From: [Peter L. Britz](#)
To: [Kimberli Kienia](#); [Peter M. Stith](#)
Subject: Fwd: 581 Lafayette Road
Date: Tuesday, March 5, 2024 11:15:15 AM
Attachments: [image001.png](#)

From: [JAH](#)
To: [Peter L. Britz](#); [Peter M. Stith](#); [Dave J. Desfosses](#); [Zachary M. Cronin](#); [Shanti R. Wolph](#); [Eric B. Eby](#); [Patrick R. Howe](#); [Kimberli Kienia](#); [Kate E. Homet](#); [GOV Mike Maloney](#)
Cc: [Trevor McCourt](#)
Subject: 581 Lafayette Road
Date: Thursday, January 4, 2024 9:48:50 PM
Attachments: [581 Lafayette Rd Parking.pdf](#)
[LU22-07 Parking Needs Analysis 2022-05-19 \(7\).pdf](#)

From: [Cheryl Coviello](#)
To: [Planning Info](#)
Cc: footkip@yahoo.com
Subject: TAC 5 March 2024 Meeting: 822 US Rt 1 Bypass Application - comments and questions
Date: Tuesday, March 5, 2024 9:13:08 AM
Attachments: [image001.png](#)
[image004.png](#)

822 US Rt 1A By-Pass TAC Application Comments and Questions

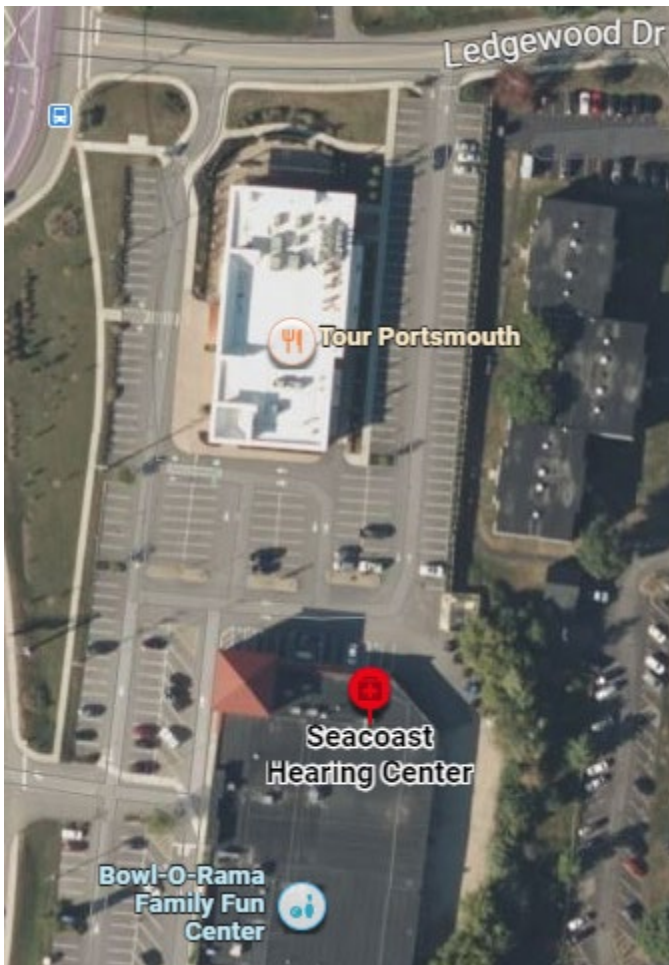
1. Attached is an easement plan that shows rights between the adjacent properties.
2. The tenants and guests of our property, 599 Lafayette (aka Bowl o Rama Plaza) will need uninterrupted access to and from Ledgewood drive and to and from drive lanes around our building to the rear of the property.
3. The head-in parking spaces to Convenient Md and Seacoast Hearing Center (near a circled 13 on the attached plan) will need uninterrupted access and a reasonable drive lane.
4. Visibility and access to air, light and emergency vehicles is critical to Convenient MD and Seacoast Hearing Center (both facing Ledgewood Drive per the snip below)
5. While there is cross parking and driving access is allowed between the properties, please do not allocate any of our property's parking to others – we have redevelopment plans in the future and expect that we will need all of our land and improvements.

PROPOSED LIGHTING			
	DESCRIPTION	CATALOG NUMBER	QUANTITY
2 lamps, 20'	LIGHT POLE (LP1)	KT-ALED210-L2-OSA-NM-850-VDIM_I	1
1 lamp, 20'	LIGHT POLE (LP2)	KT-ALED210-L2-OSA-NM-850-VDIM	1
15'	WALL PACK (LP3)	KT-WPLED55PS-M4-8CSB-VDIM	2
8'	DOWNLIGHT (LP4)	KT-RDLED18PS-6A-9CSE-VDIM (I)	6

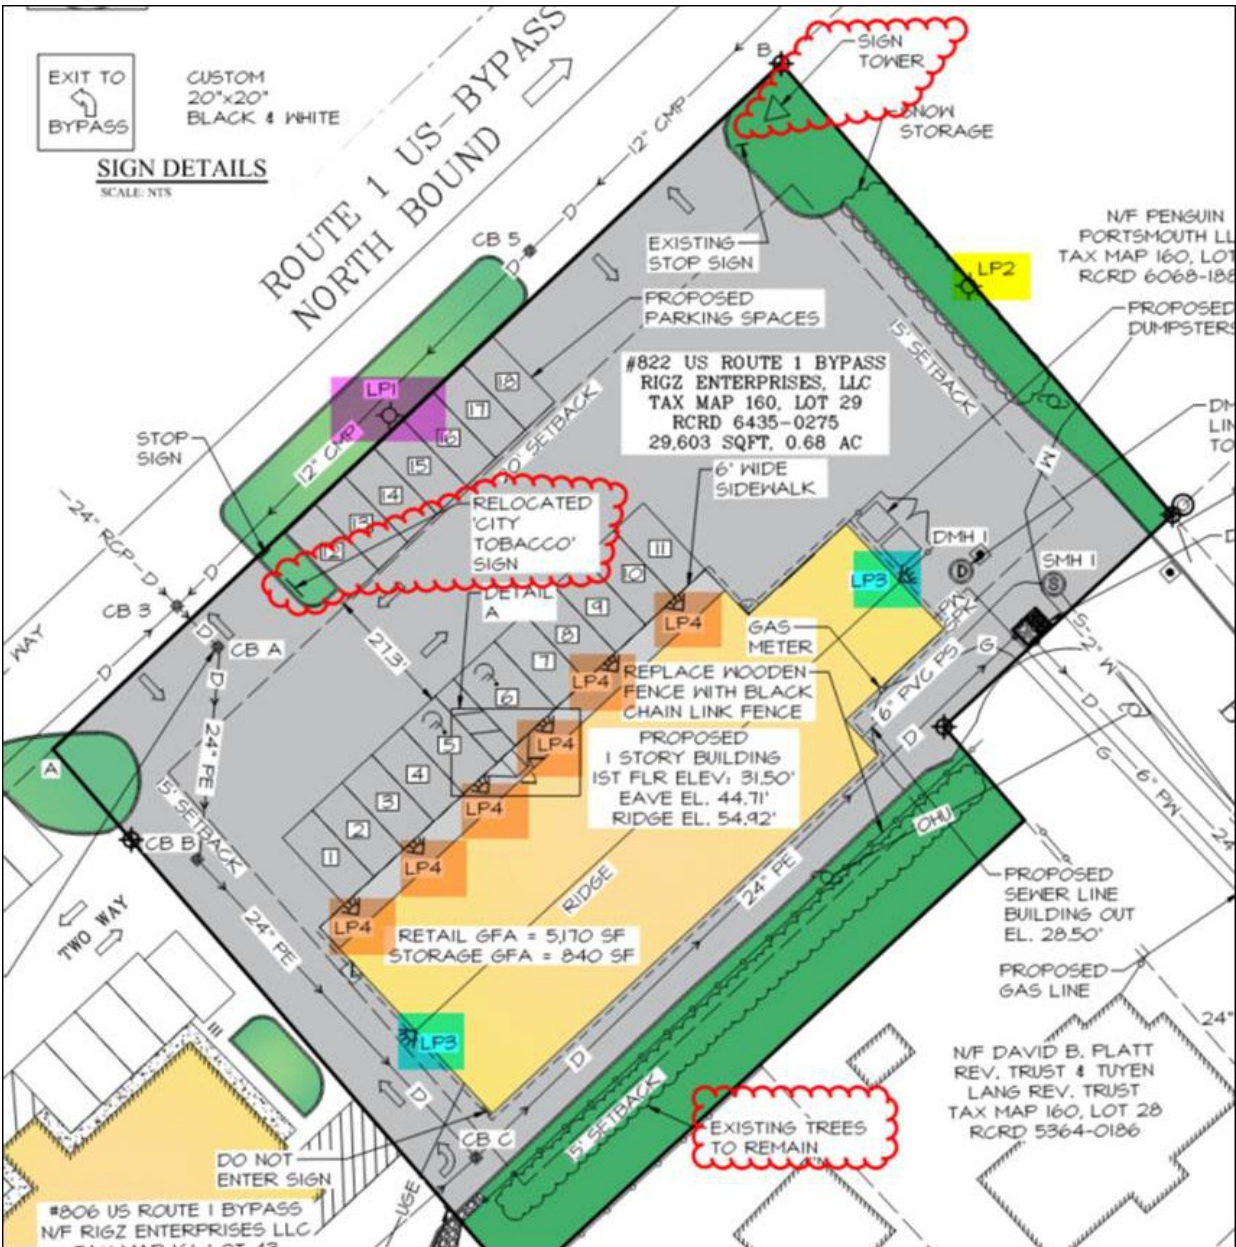
I color coded the lighting plan to the lighting schedule. Snippets below.

- The catalog numbers provided for the lights on the poles (20') come preset to 5000K with ability to switch to 3000 K or 4000K. The fixture appears to be dimmable.
- The catalog number for the wall packs (15') has letters where it should have numbers to indicate the light color. I assume these would also be 5000K. The cut sheet shows 4000k or 5000k. The fixture is dimmable.
- The catalog number for the down lights (6" diameter at 8') has a letter where it should have the number to indicate the light color. I assume these would also be 4000K. (Options are 3000K, 3500K and 4000K.) The fixtures are dimmable.
- The rendering of the lighting shows light mostly on the property.

1. Can the lighting be required to be set at 3000K? If not 3000K, can they be 4000K? 5000k is bright and harsh.
2. The lighting spec sheets indicate that they are dimmable.

- a. Can the lighting on one of the poles be turned off at night?
 - b. Can the wall lights, downlights and other pole be dimmed to 50% or less at night?

- c. While the lighting is indicated to be dark sky friendly (except for the downlights), the parcel is at a higher elevation than the abutting neighborhood and light can be seen from a distance and impact the residences. We know this based on the lighting from other businesses along the By-pass: Penguin (former O'Brien's and closer to us than the subject application), Shell (on the west side of the overpass to New Franklin School and farther from us than the subject application), and the adult store on the south side of the By-pass.

- d. The previous gas station used to turn off most if not all of the lights at night.
3. Can the wall lights be motion sensed?
4. Can the lighting rendering be revised to include the effects of the lighting of adjacent properties? As visible in the site photographs, there is lighting on both the east and west corners along the By-pass. Note that these existing lights are not shown in the submitted drawings.
